APPLICATION NO.	FILING DATE	FIRST NAMED INVENTOR	ATTORNEY DOCKET NO.	CONFIRMATION NO.
10/735,440	12/12/2003	Fabian Kollmann	3201-366 (D4700-00380)	2028

Office Action Summary

SN 10/735,440
Substitute Drawing

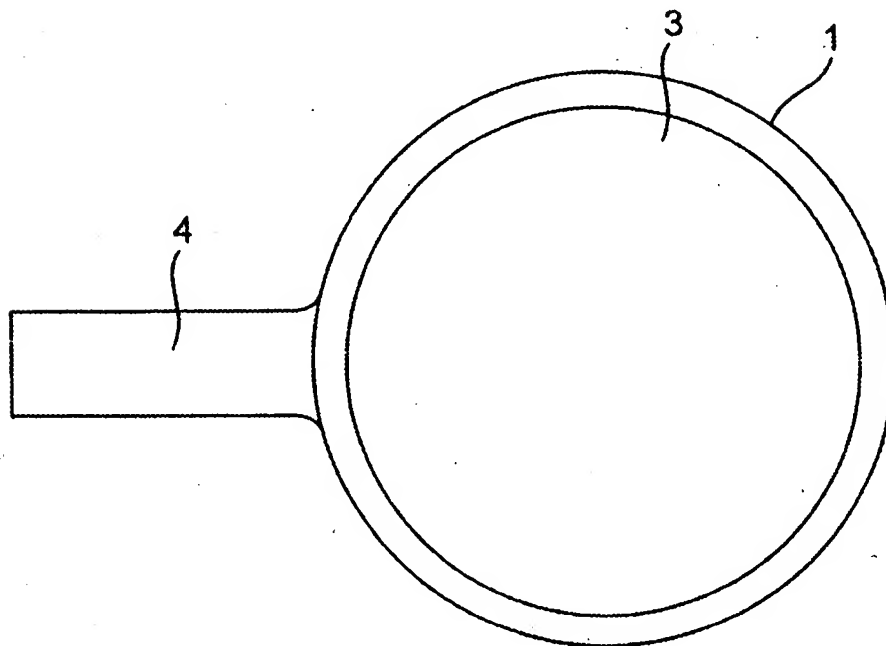
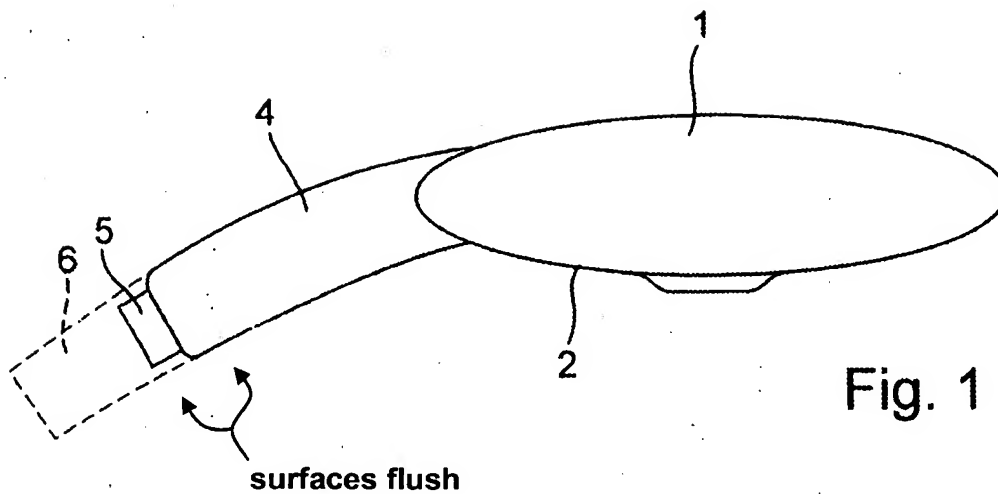
The proposed drawing correction filed on 9/28/07 is disapproved as the depiction of the union nut is inconsistent with that of the original drawings in that the double lines at the hose end are lacking, the fitting is of a different shape and the terminal end of the handle is rounded.

not approved
11/9/07 CEP
